2026MY
Sportage (NQ5)
Sportage Hybrid/Plug-In Hybrid
(NQ5 P/HEV)

TECHNICAL SERVICE BULLETIN

WIND NOISE FROM FRONT LEFT DOOR (CA2601)

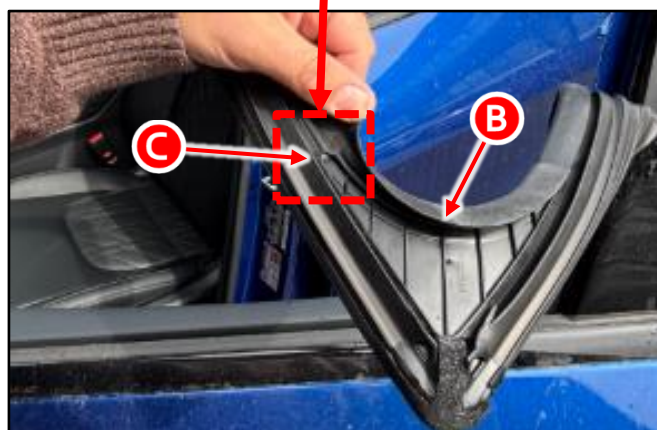
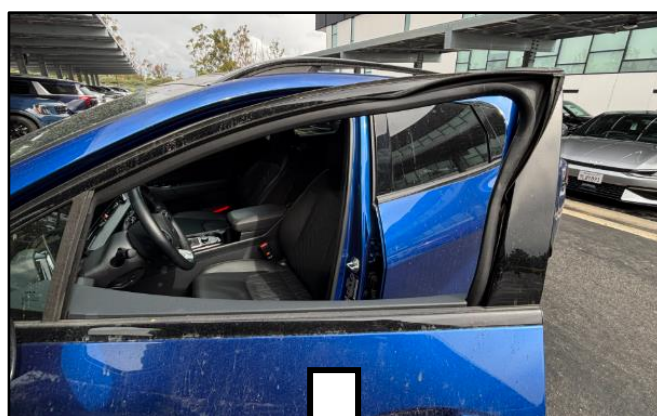
This bulletin provides information regarding a wind noise heard on certain 2026MY Sportage vehicles listed below. The affected vehicles may experience wind noise coming from the front left door while driving. Wind can travel through the run channel of the upper corner of the window run. Follow the procedure outlined in this publication to install an Ethylene Propylene Diene Monomer 'EPDM' foam pad on the front left door window run on the applicable vehicle. Before performing the repair, verify that the vehicle is included in the list of affected VINs.

1. Turn the ignition to 'ACC' or 'ON'.
2. Roll down the front left window.
3. Locate the front left door window run (A).
4. From the **outside** of the door, pull down the top right corner of the window run (A), as shown.
5. Flip the window run (A) down.
6. Peel the window run flap (B) back, as shown.
7. Locate the boundary line (C).
